Access Compliance Report

Public Rights-of-Way

Intersection ID: 11972	Main Street: N_POPLAR_ST	Cross Street: W_5TH_ST	Location: W
ADA ID: CDF973D6A000	Ramp Type: PerpDiag	Initial Pass/Fail: Fail	Overall Compliance: No
			Severity Score: 10

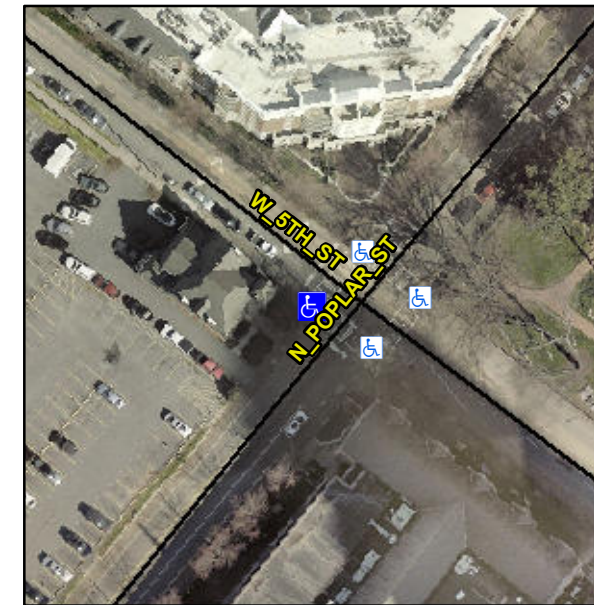
Not Found, R304.5.1, R304.5.3

Compliance	Description	Data	Compliance	Description	Data
N/A	Ramp Length (in)	64.0	Yes	Ramp Slope (%)	8.1
No	Ramp Width (in)	44.0	No	Ramp XSlope (%)	4.8
N/A	Flare Type LT	N/A	N/A	Flare Type RT	N/A
N/A	Flare Slope LT (%)	N/A	N/A	Flare Slope RT (%)	N/A
N/A	Flare Traversable LT?	N/A	N/A	Flare Traversable RT?	N/A
N/A	Landing Length (in)	N/A	N/A	DWS Provided?	N/A
N/A	Landing Width (in)	N/A	N/A	DWS Contrast?	N/A
N/A	Landing Slope (%)	N/A	N/A	DWS Length (in)	N/A
N/A	Landing X Slope (%)	N/A	N/A	DWS Full Width?	N/A
N/A	Landing Curb? (Y/N)	N/A	N/A	DWS Offset (in)	N/A
N/A	Shared Landing?	N/A			
N/A	Gutter Ponding?	N/A	N/A	Gutter Slope (%)	N/A
N/A	Gutter Lip Ht (in)	N/A	N/A	Gutter X Slope (%)	N/A
N/A	Painted X Walk1?	Yes	N/A	Painted X Walk2?	Yes
	X Walk 1 Direction	To SE		X Walk 2 Direction	To NE
N/A	X Walk 1 Width (in)	112.0	N/A	X Walk 2 Width (in)	113.0
	X Walk 1 Slope (%)	3.1		X Walk 2 Slope (%)	1.4
	X Walk 1 X Slope (%)	1.4		X Walk 2 X Slope (%)	1.8

Remove & Replace Curb Ramp With Two New Directional Ramps or Equivalent.
